UNITED STATES PATENT AND TRADEMARK OFFICE

APPLICATION NO.	FILING DATE	FIRST NAMED INVENTOR	ATTORNEY DOCKET NO.	CONFIRMATION NO.
10/708,467	03/05/2004	Richard F. Wenstrom JR.	MIT5027USNP	2466

Office Action Summary	Application No. 10/708,467	Applicant(s) WENSTROM ET AL.	
	Examiner MARY HOFFMAN	Art Unit 3733

DETAILED ACTION

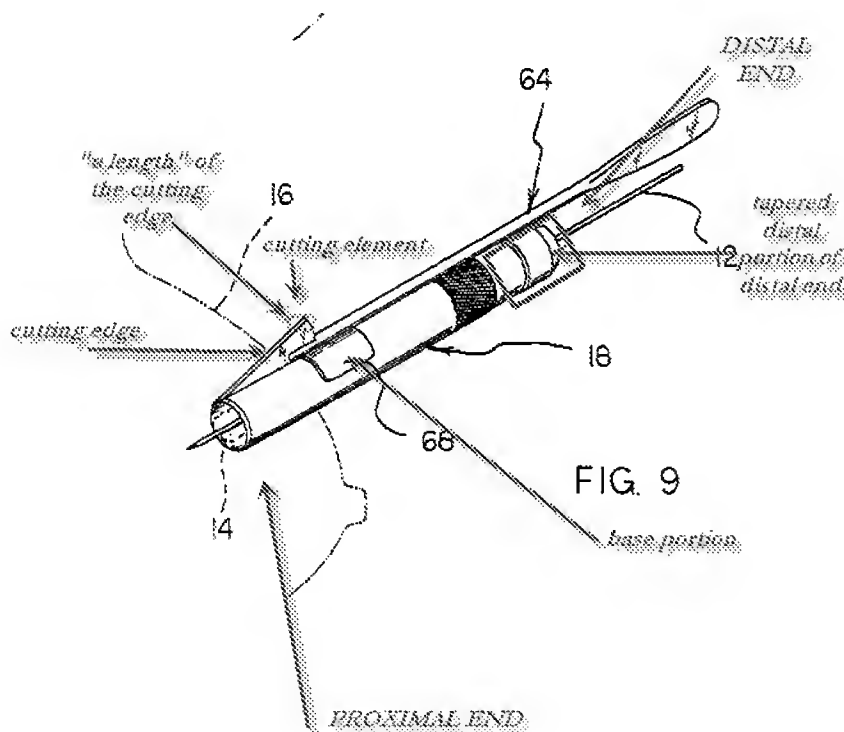
Russin discloses a tunnel notcher and guidewire delivery device, comprising an elongate member with proximal and distal ends (see marked-up figure below) and an

inner lumen extending therebetween, the inner lumen being adapted to receive a guidewire (ref. #12); and a cutting element (ref. #72) disposed proximal to the distal end of the elongate member and adapted to remove bone, i.e. capable of removing bone, within an opening of a bone tunnel, the cutting element being substantially wedge-shaped and extending radially outward from the elongate member. The cutting edge (see marked up figure) is spaced away from the elongate member (when ref. #68 is advanced to the proximal end, not illustrated) and extends not normal to the angle member.

A distal portion of the distal end of the elongate member is substantially tapered (ref. #22, sharpened edge). The cutting element is disposed proximal to the substantially tapered distal portion of the elongate member. The cutting element

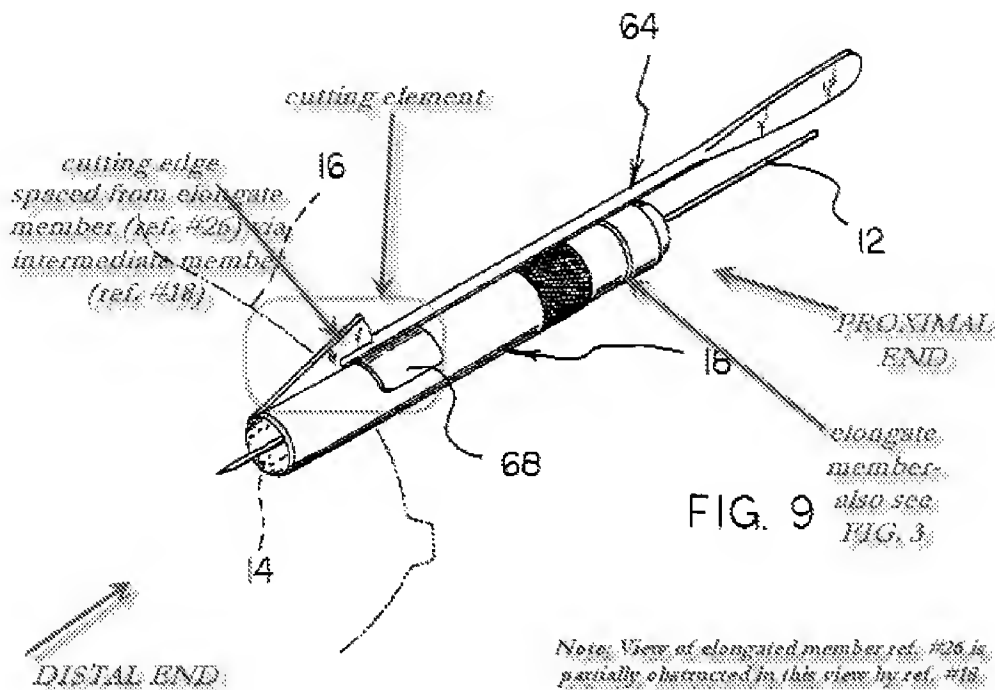
includes a base portion (ref. #68) coupled to the elongate member and the cutting edge positioned a distance apart from the elongate member.

The cutting edge has “a length” less than the diameter of the elongate member (see marked-up figure). The cutting element is adapted to create a notch in bone having a substantially semi-circular shape.

The device further comprising a plurality of indicia (shown at ref. #36 in FIG. 1) formed on a distal portion of the elongate member and adapted to indicate a depth of the elongate member within a bone tunnel.

The distal portion has a length greater than “a length” of the cutting element (ref. #72).

According to another interpretation, Russin discloses a device comprising an elongate member (ref. #26, FIG. 3) with proximal and distal ends and an inner lumen extending therebetween, the inner lumen being adapted to receive a guidewire (ref. #12); and a cutting element (ref. #70) having a distal bone cutting edge disposed proximal to a distal portion of the elongate member (when the cutting element is first advanced along the device, *i.e.* prior to the orientation shown in Fig. 9), and being spaced away from the elongate member (via ref. #18, FIG. 2), the cutting element being adapted to remove bone within an opening of a bone tunnel, the cutting element being the only cutting element disposed on the elongate member and being substantially wedge-shaped and extending radially outward from the elongate member.

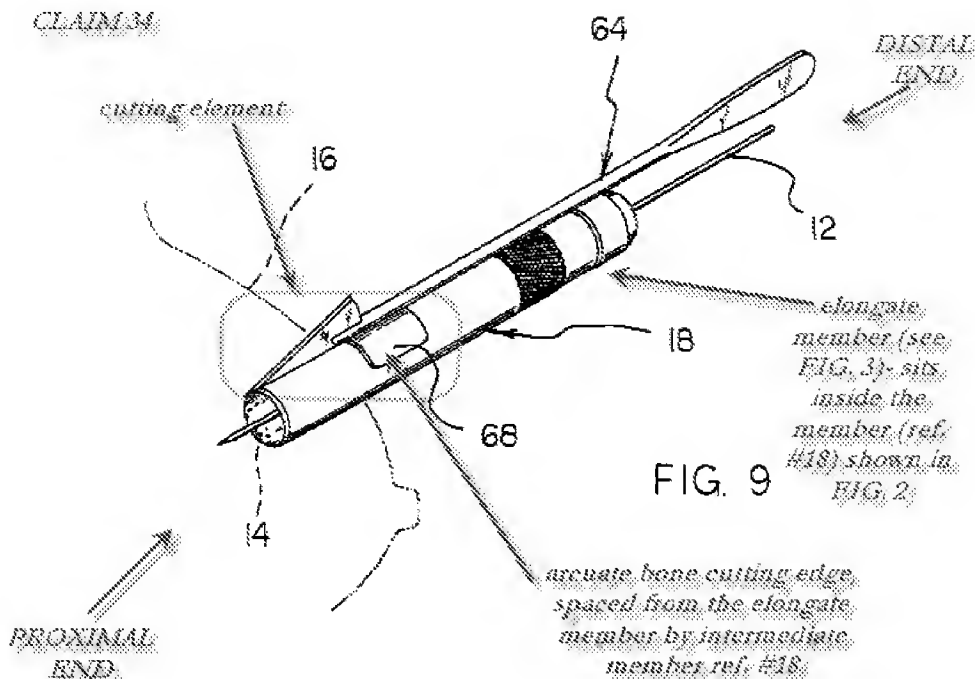
Regarding claim 34, Russin discloses a device (see next marked-up figure) comprising an elongate member (FIG. 3) with proximal and distal ends and an inner lumen extending therebetween, the inner lumen being adapted to receive a guidewire (ref. #12); and a single cutting element (ref. #'s 68 and 70) disposed proximal to the distal end of the elongate member and adapted to remove bone within an opening of a bone tunnel, the cutting element being the only cutting element disposed on the elongate member and being substantially wedge-shaped (at ref. #70) and extending radially outward from the elongate member and having a bone cutting edge (front edge of ref. #68) that has a substantially arcuate shape spaced apart from and circumferentially oriented with respect to the elongate member.

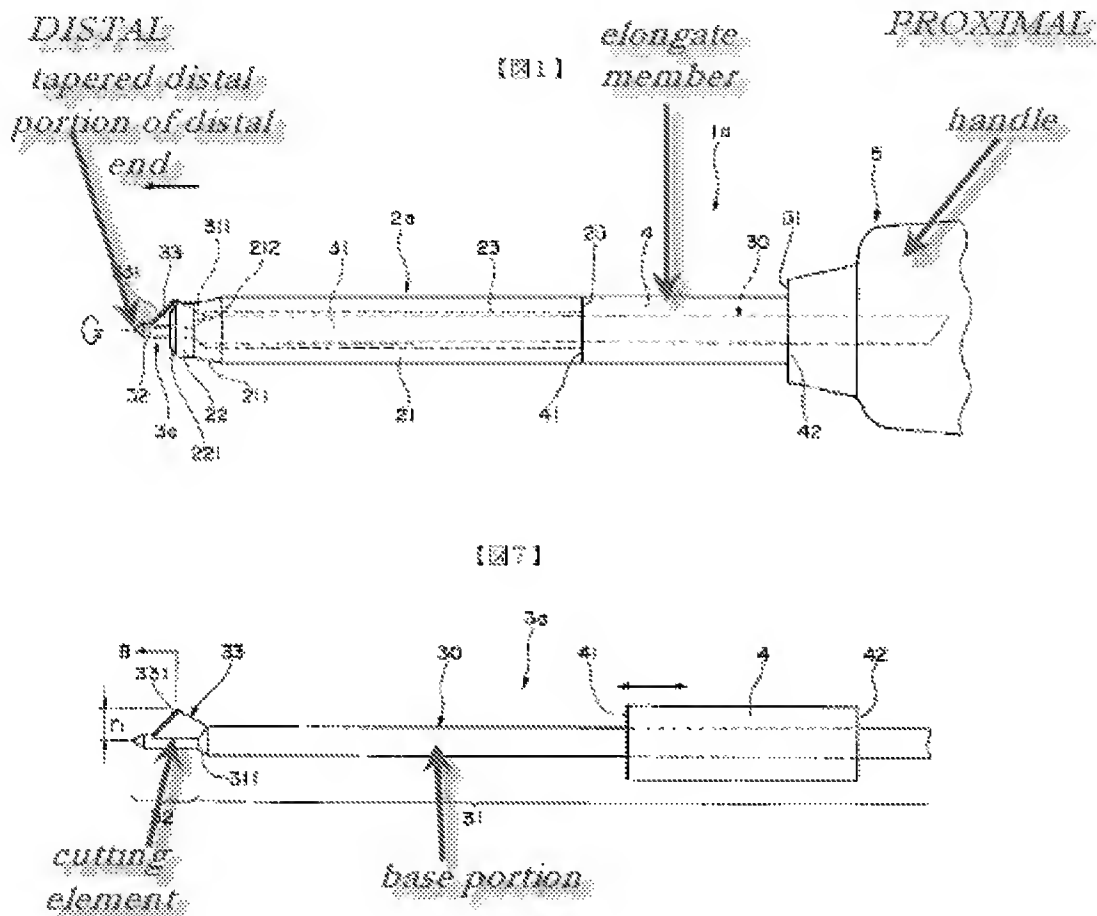
Akiyama Hitoshi discloses a tunnel notcher and guidewire delivery device, comprising: an elongate member (ref. #4) with proximal (right) and distal ends (left) and an inner lumen extending therebetween, the inner lumen being adapted to receive a guidewire; and a cutting element (ref. #33) having a distal bone cutting edge disposed proximal to a distal portion of the elongate member (when the cutting element is being advanced from the right to left, not illustrated), and being spaced away from and not normal to the elongate member, the cutting element being adapted to remove, *i.e.* capable of removing, bone within an opening of a bone tunnel, the cutting element

being the only cutting element disposed on the elongate member and being substantially wedge-shaped and extending radially outward from the elongate member.

A distal portion of the distal end of the elongate member is substantially tapered (see tapered tip of ref. 32 in Fig. 7). The cutting element is disposed proximal to the substantially tapered distal portion of the elongate member.

The cutting element includes a base portion (ref. #30) coupled to the elongate member and a cutting edge positioned a distance apart from the elongate member.

The cutting edge is positioned distal to the base portion.
